Pre-Design Investigation
(Additions)

DATE	JUNE 11, 1987	JOB NO.	QUEEN OF HEAVEN
FROM	CLAUDE VIGIL ARCHITECTS		
TO	QUEEN OF HEAVEN ADDITION		
PROJECT	6303 PHOENIX AVE., N.E.		
LOCATION	ALBUQUERQUE, NEW MEXICO

RE: ADDITION TO QUEEN OF HEAVEN - LIBRARY & KINDERGARDEN
(H-18/D46) RECEIVED JUNE 11, 1987

SITE

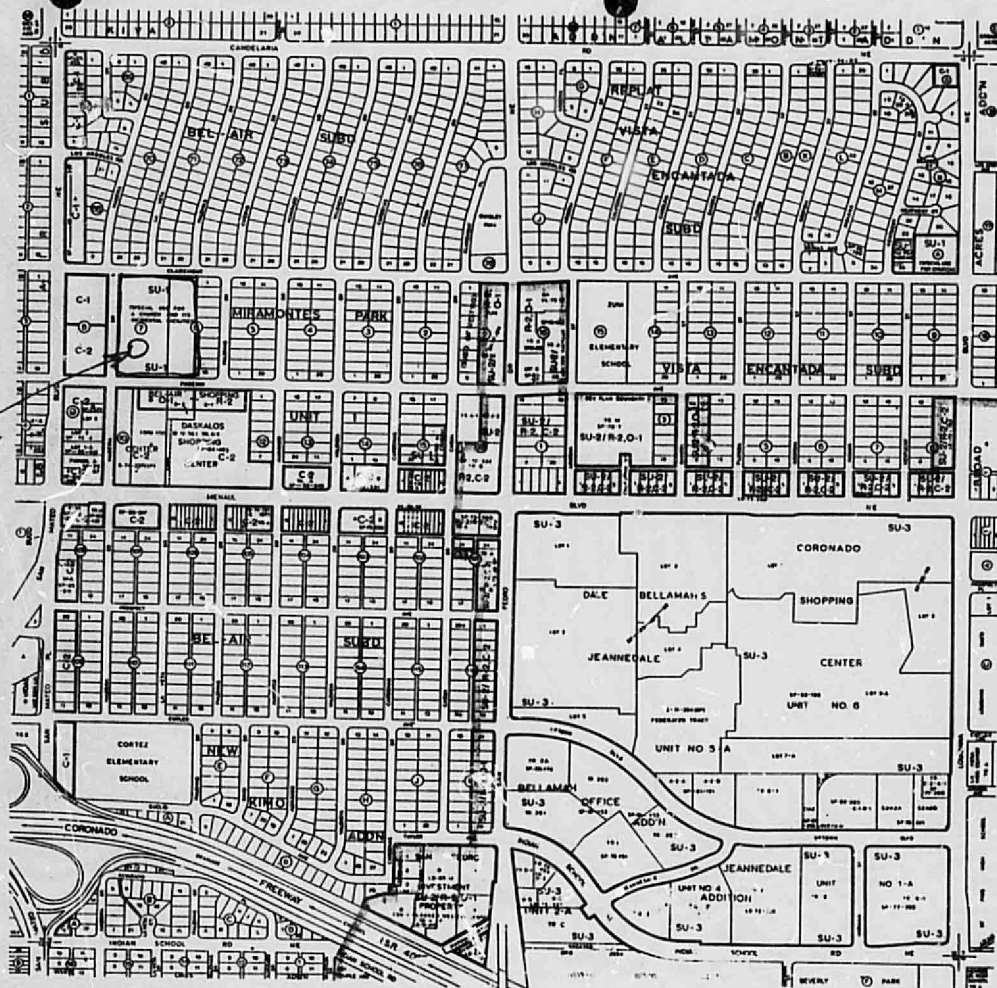
YES	NO	NA	COMMENTS
FLOOD HAZARD AREA	<u>NO-1'</u>			<u>Clearance is in a floodzone not the addition</u>
PART OF AN APPROVED REPORT		<input checked="" type="checkbox"/>		
CONSTRUCTION PLANS ON MICRO-FILM		<input checked="" type="checkbox"/>		
FIELD INSPECTION	<input checked="" type="checkbox"/>

The referenced addition will not need a drainage plan. The only construction approved is the 21' x 107' addition. The reason why a drainage plan is not needed is:

1. The building is not in a flood zone;
2. there is minimum impact on downstream facilities;
3. site is not part of a master plan;
4. a field inspection indicates no problems.
